**ADDENDUM 2 – JOB 10**

TO: All prospective bidders on Project NHU-6-986(131), Job No. 10 scheduled for the March 12, 2021 bid opening.

**PLAN ADDENDUM SUMMARY AND APPROVAL**

PROJECT INFORMATION			
<b>Project:</b>	NHU-6-986(131)	<b>PCN:</b>	22682
<b>Location:</b>	Grand Forks, ND		
<b>Date:</b>	3/3/2020	<b>Lead Designer:</b>	KLJ
<b>Bid Opening Date:</b>	March 12, 2021	<b>JOB#:</b>	10
		<b>Addendum#:</b>	2

TABLE 21.07 - REQUIRED MIN. DENSITY

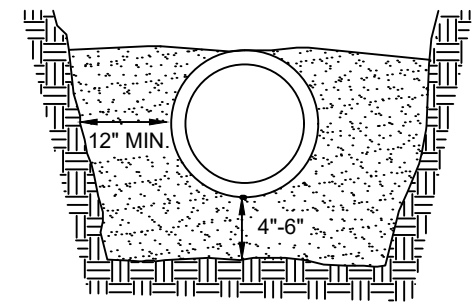
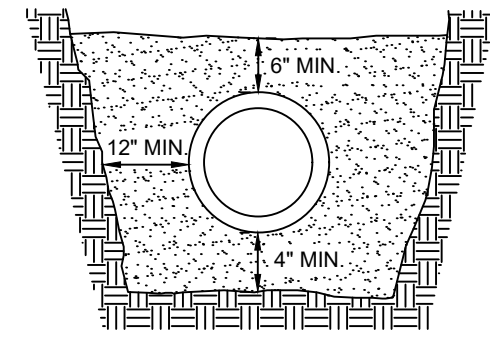
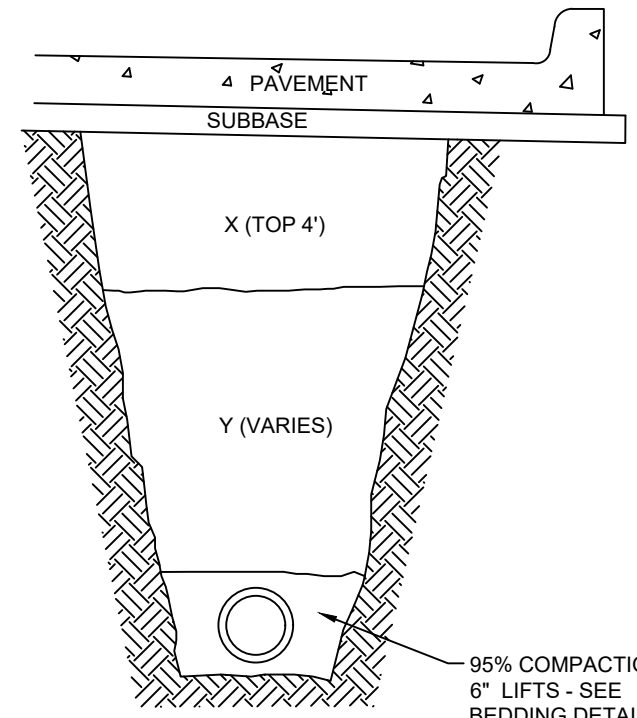
20	2	Revised Table 21.07 – "...COMPACTED TO A MINIMUM OF 95% OF MODIFIED PROCTOR AT 2-6%OVER OPTIMUM MOISTURE."
90	2	Added bid item 750 2115 "Detectable Warning Panels"
90	3	Added bid item 750 2115 "Detectable Warning Panels"
100	2	Revised phasing
100	3	Revised phasing
100	5	<ul style="list-style-type: none"> <li>• Revised custom sign for "SIDEWALK CLOSED UTILIZE PEDESTRIAN UNDERPASS OR SKYWAY" from 9"x24" to 18"x24".</li> <li>• Revised phasing</li> </ul>
100	6	<ul style="list-style-type: none"> <li>• Revised custom sign for "SIDEWALK CLOSED UTILIZE PEDESTRIAN UNDERPASS OR SKYWAY" from 9"x24" to 18"x24".</li> <li>• Revised phasing.</li> </ul>
100	7	<ul style="list-style-type: none"> <li>• Revised custom sign for "SIDEWALK CLOSED UTILIZE PEDESTRIAN UNDERPASS OR</li> </ul>

\* ALL GRANULAR MATERIAL - SEE SPEC. 21.07  
\* ON ALL STREET CROSSINGS, GRANULAR BACKFILL WITH A 3' CLAY CAP SHALL BE INSTALLED. CLAY SHALL BE COMPACTED TO A MINIMUM OF 95% OF MODIFIED PROCTOR AT 2-6% OVER OPTIMUM MOISTURE.

Revised 3/2/2021	STATE	PROJECT NO.	SECTION NO.	SHEET NO.
	ND	NHU-6-986(131)	100	8

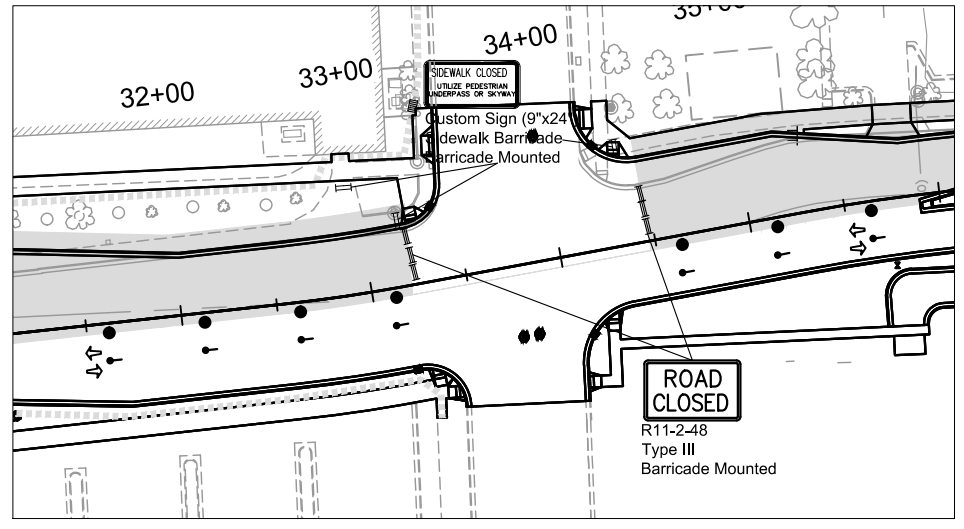
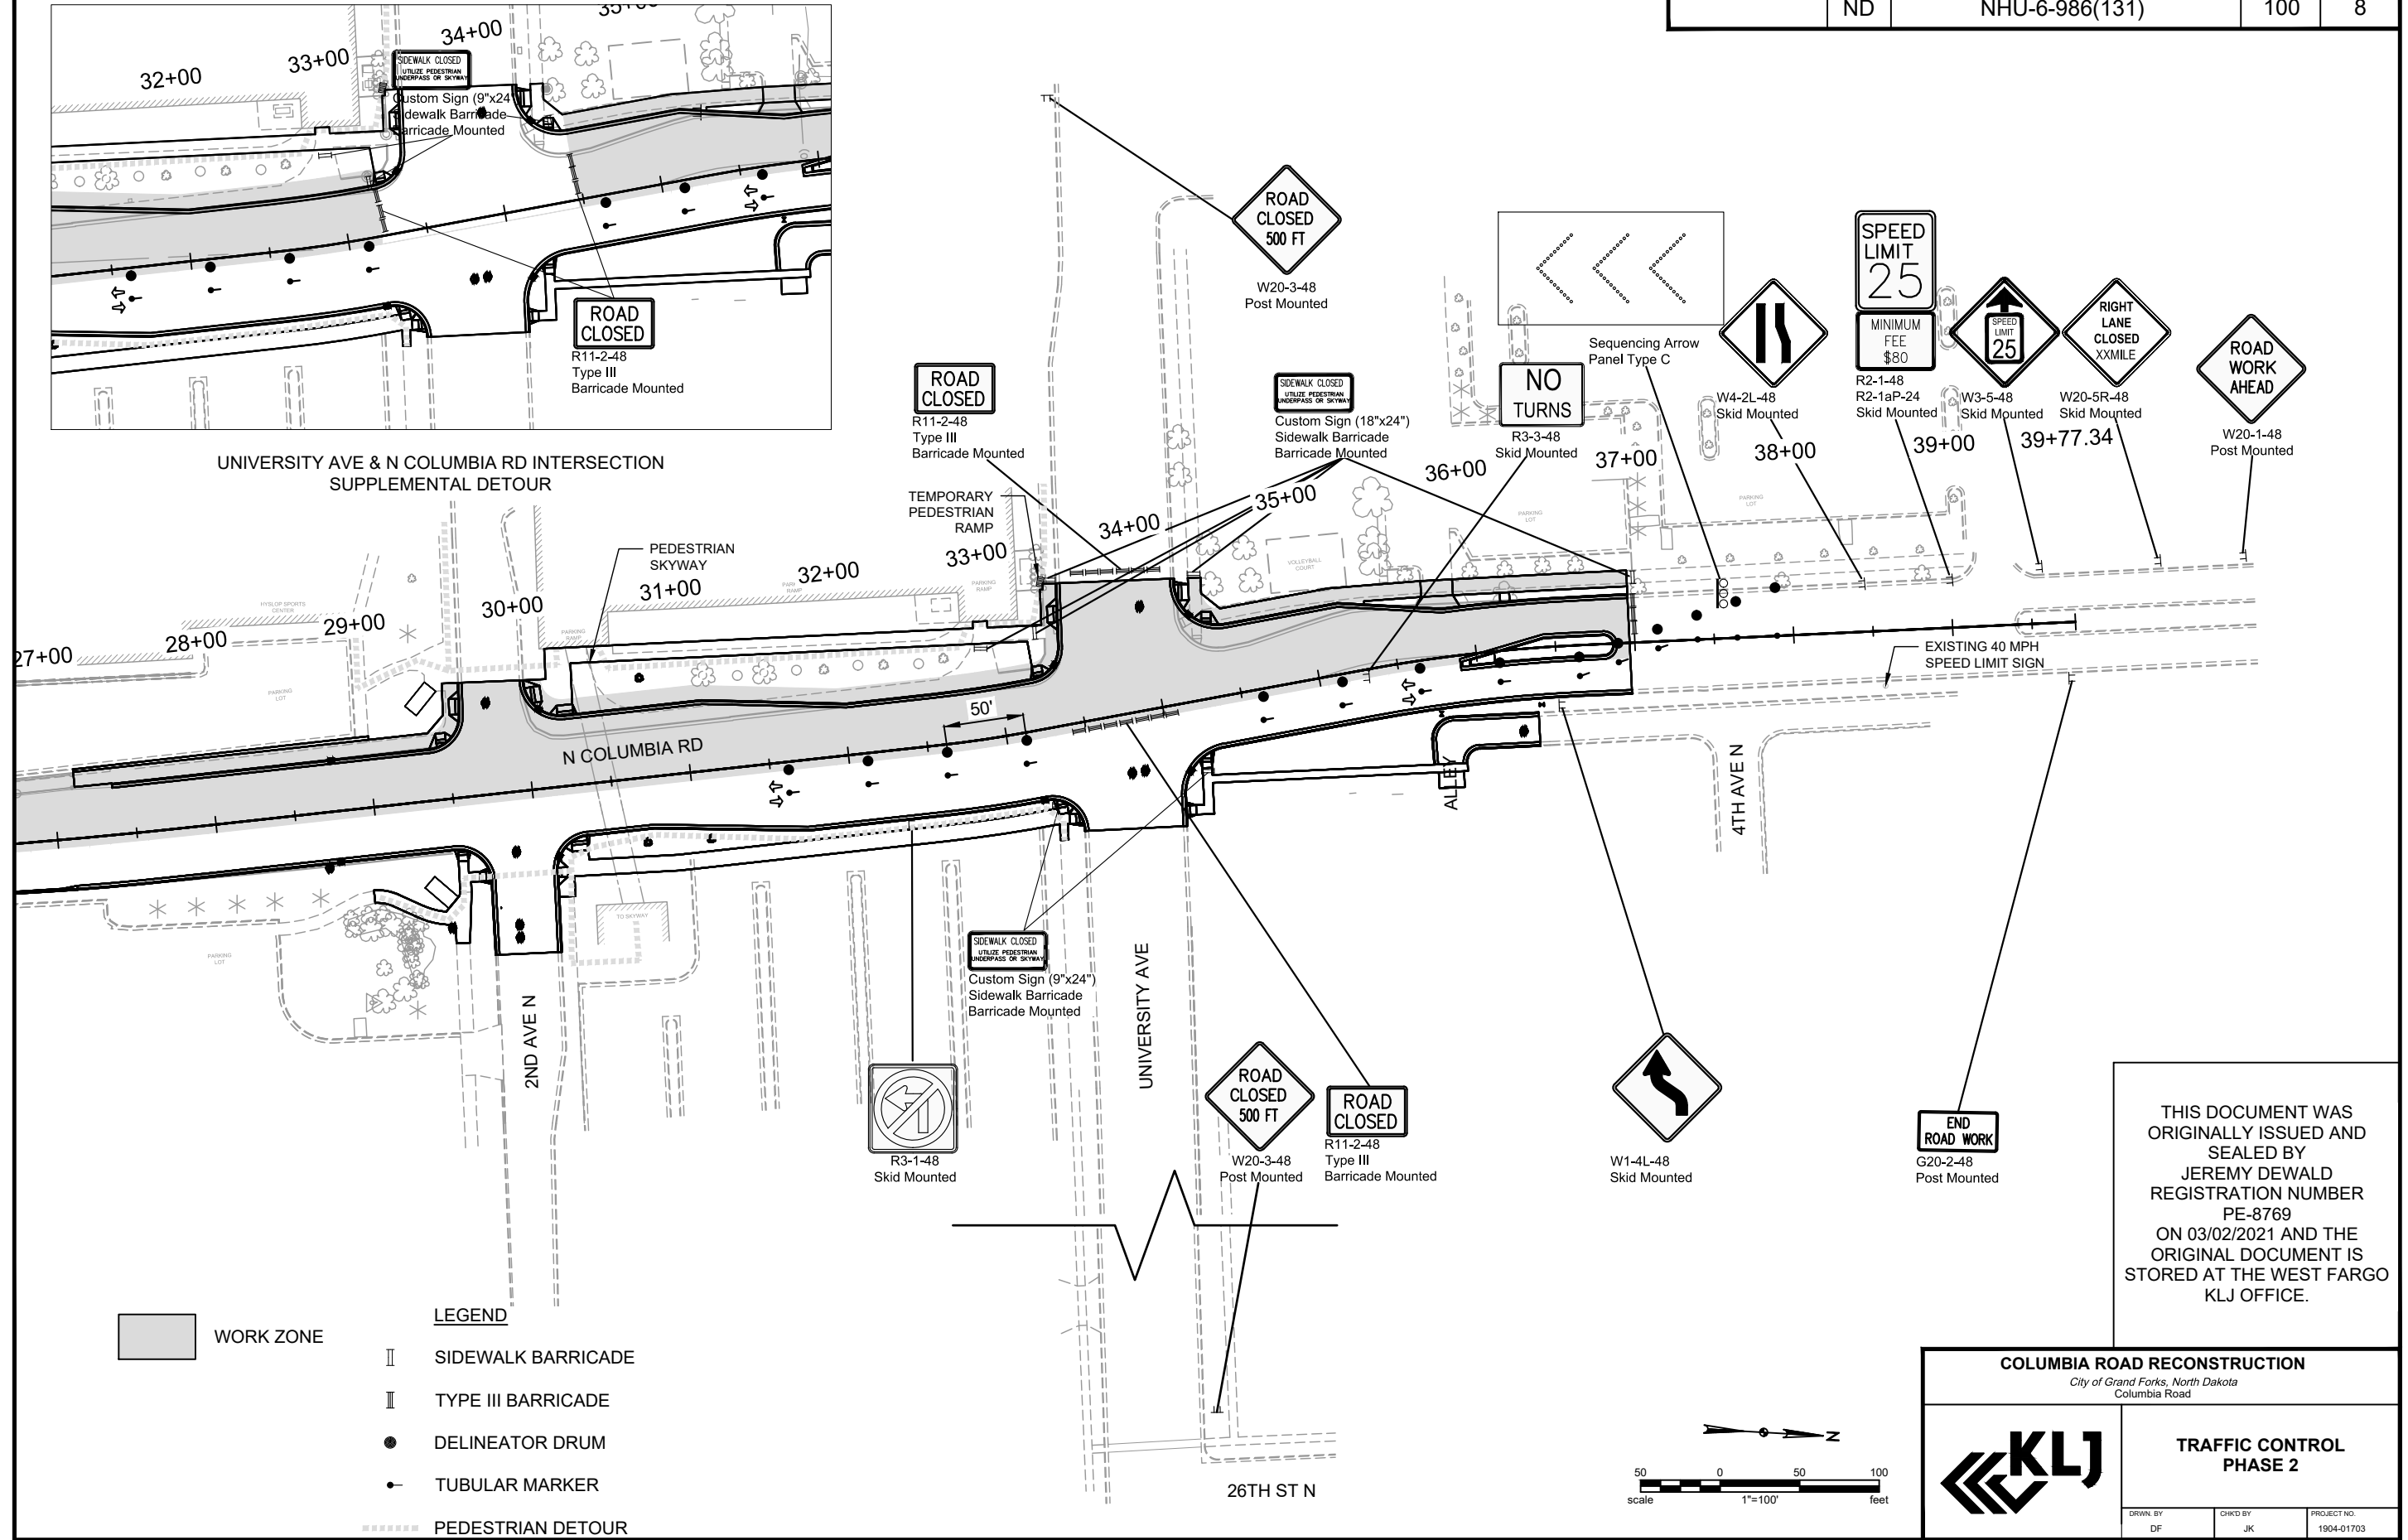
SKYWAY" from 9"x24" to 18"x24". • Revised phasing.
100	8	• Revised custom sign for "SIDEWALK CLOSED UTILIZE PEDESTRIAN UNDERPASS OR SKYWAY" from 9"x24" to 18"x24". • Revised phasing.
150	8	Updated signal head numbering in lower left corner of sheet.
199	2	Removed "Forcemain ARV Structure"
199	4	Removed "Forcemain ARV Structure"
199	8	Removed sheet
199	9	Removed sheet
199	10	Removed sheet
